Manufacturing Bulletin

Subject: Carrier Tape Pocket Design Change - Reel Shipment

Affected Product List: AMB0480A5RJ, AMB0480A5RH

Photos

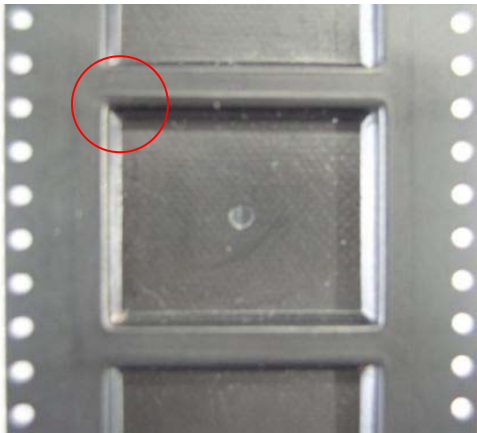
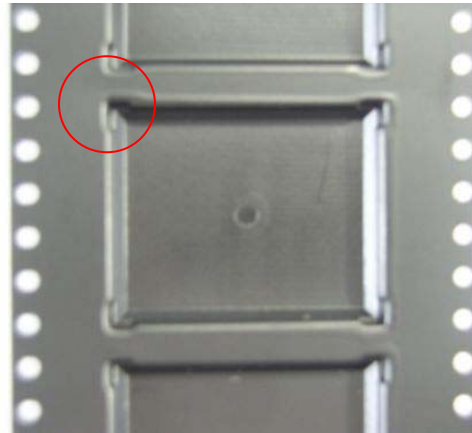
Integrated Device Technology, Inc has introduced a new carrier tape pocket design for AMB product shipped in reel form. Kindly refer to the attachment for the new design which is known as the “dog bone” design. The purpose of this change is to improve the device pick up process at the customer SMT machine. The “dog bone” design provides 4-corner relief to eliminate friction between device corners and the pocket corners during the pick and place at board mount process. This new design has been tested and meets ASTM D5276-98, Standard Test Method for Drop Test of Loaded Containers by Free Fall.
